Product Change Notification—PCN001203**Jun 25, 2026**

- **CP-132EL Series**
- **CP-118E-A-I/138E-A-I Series**
- **CP-134EL-A-I Series**
- **CP-114EL Series**

Product photo of the **CP-132EL** models

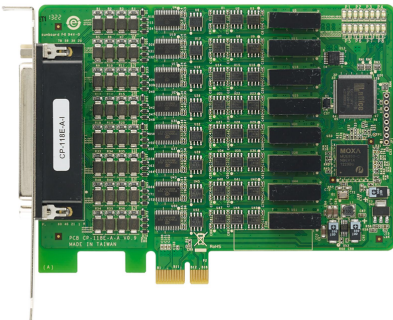
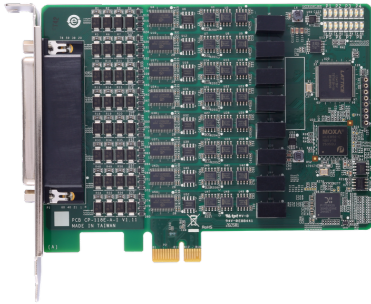
CP-132EL-DB9M	
Current Version HW Rev 1.3.1	New Version HW Rev 1.4.0

CP-132EL-I-DB9M	
Current Version HW Rev 1.4.1	New Version HW Rev 1.5.0

- An enhanced board design by incorporating a PCIe switch bridge.

Product photo of the **CP-118E-A-I w/o cable**

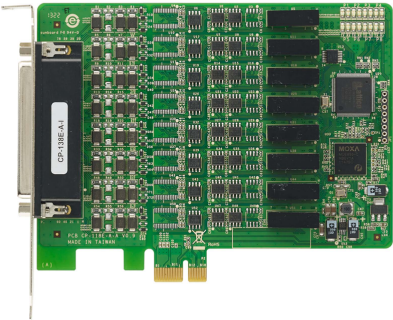
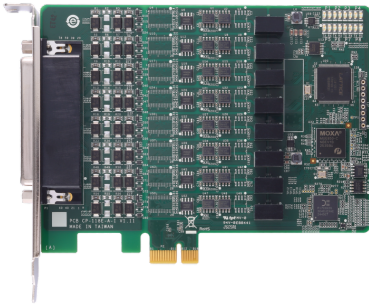
CP-118E-A-I w/o cable	
Current Version HW Rev 1.0.1	New Version HW Rev 1.1.0

Product photo of the **CP-138E-A-I w/o cable**

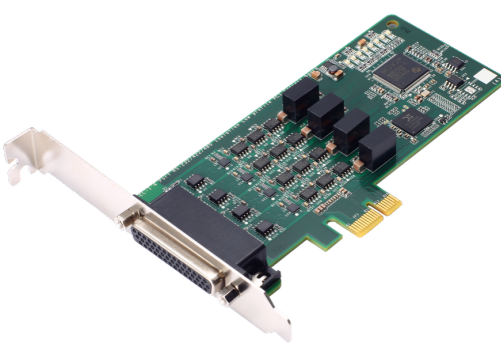
CP-138E-A-I w/o cable	
Current Version HW Rev 1.0.1	New Version HW Rev 1.1.0
